# Bid Addendum No. 1

Alderpoint Road Tank Replacement Project  
Garberville, CA

Date: February 26, 2015

Project No.: 7714.02

STATE OF CALIFORNIA  
DEPARTMENT OF TRANSPORTATION  
**CHAIN LINK FENCE**  
NO SCALE

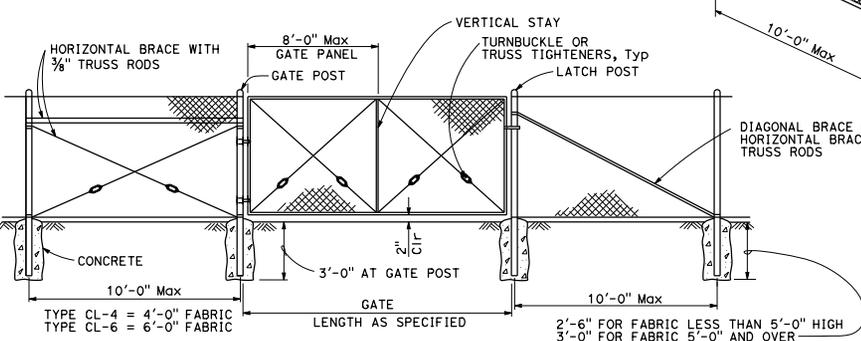
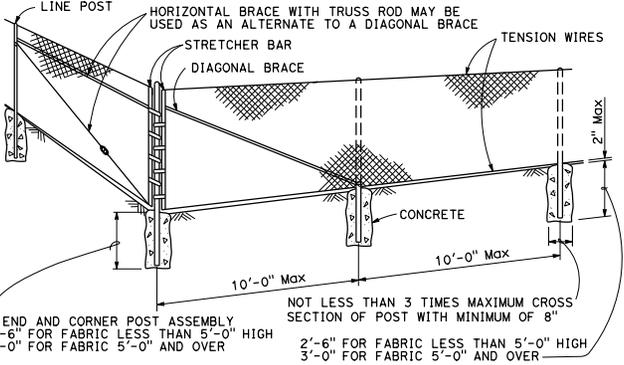
- 20. **Q: What are the dimension of the security fence and gate?** The new security fence shall be 6-foot tall chain link fencing in accordance with Caltrans Standard Plans and Specifications. The Gate shall be a 12-foot wide 6-foot tall chain link gate in accordance with Caltrans Standard Plans and Specifications. Caltrans Standard Plans A85 and A85A are included in Appendix 2.

C1.1

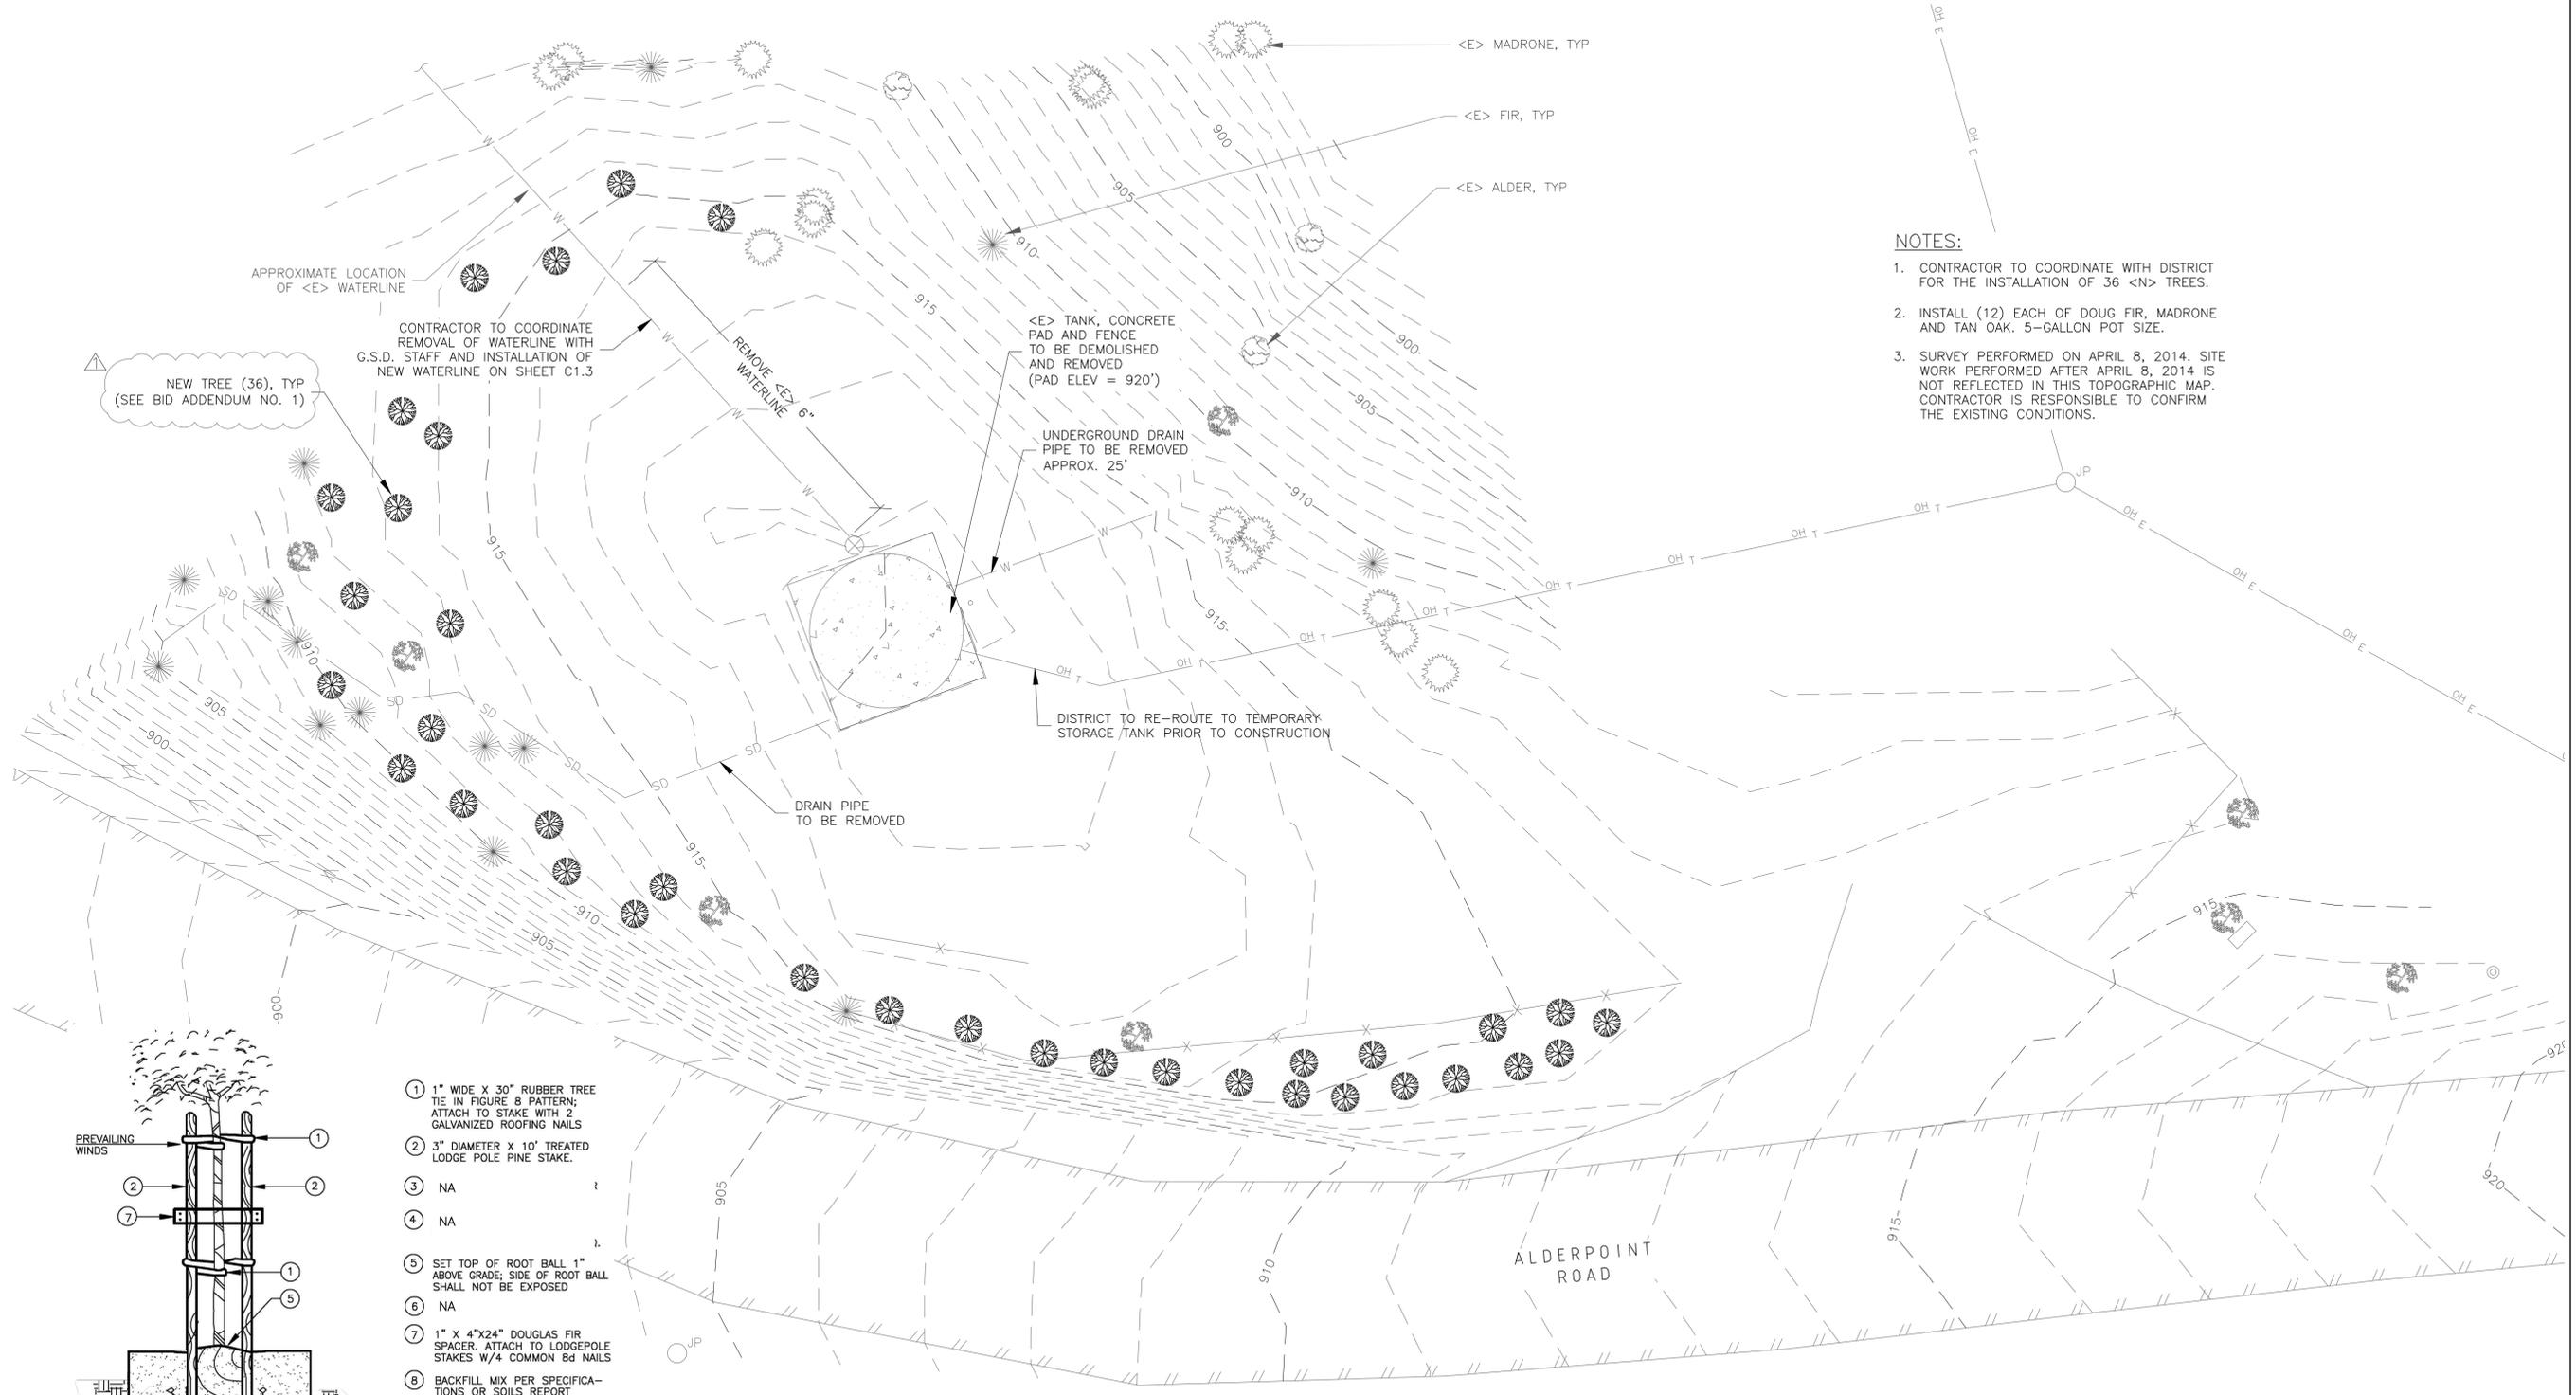
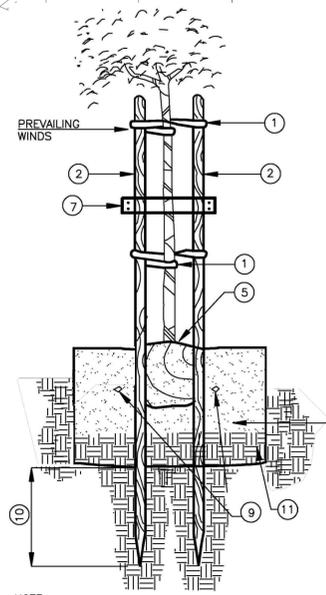
11. **Q: When will trees and shrubs be identified?** Trees shall be purchased in 5-gallon pot size, twelve (12) of each of the following species shall be installed; Madrone, Douglas Fir, and Tan Oak.

- NOTES:**
- CONTRACTOR TO COORDINATE WITH DISTRICT FOR THE INSTALLATION OF 36 <N> TREES.
  - INSTALL (12) EACH OF DOUG FIR, MADRONE AND TAN OAK. 5-GALLON POT SIZE.
  - SURVEY PERFORMED ON APRIL 8, 2014. SITE WORK PERFORMED AFTER APRIL 8, 2014 IS NOT REFLECTED IN THIS TOPOGRAPHIC MAP. CONTRACTOR IS RESPONSIBLE TO CONFIRM THE EXISTING CONDITIONS.

15 **JENSEN PRECAST VALVE VAULT**  
**LVVWD 3048** **N.T.S.**

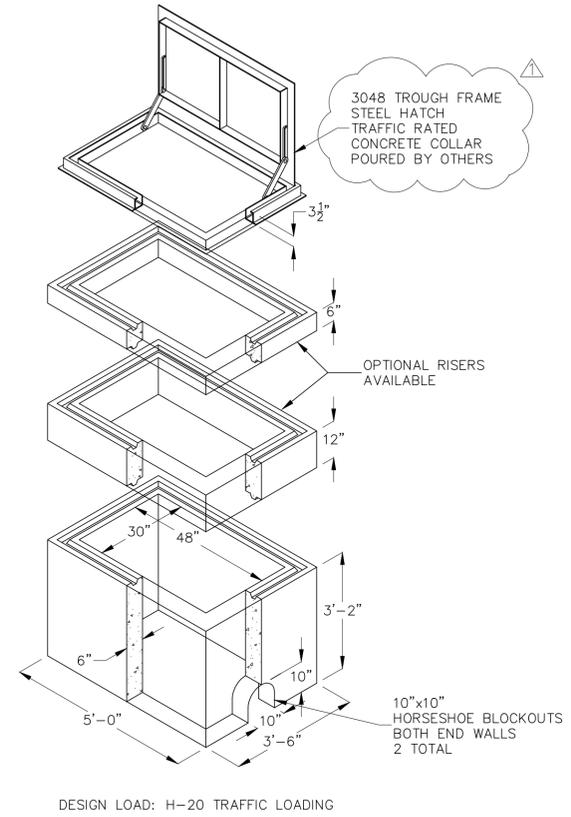
- 19. **Q: Does the valve vault have to be traffic rated.** The valve vault shall be H-20 Traffic Rated with a steel hatch. The valve vault and hatch referenced in the plans is an *Air Vac Meter Vault* manufactured by Jensen Precast #LVVWD 3048, with a Steel Hatch #CAS-3048
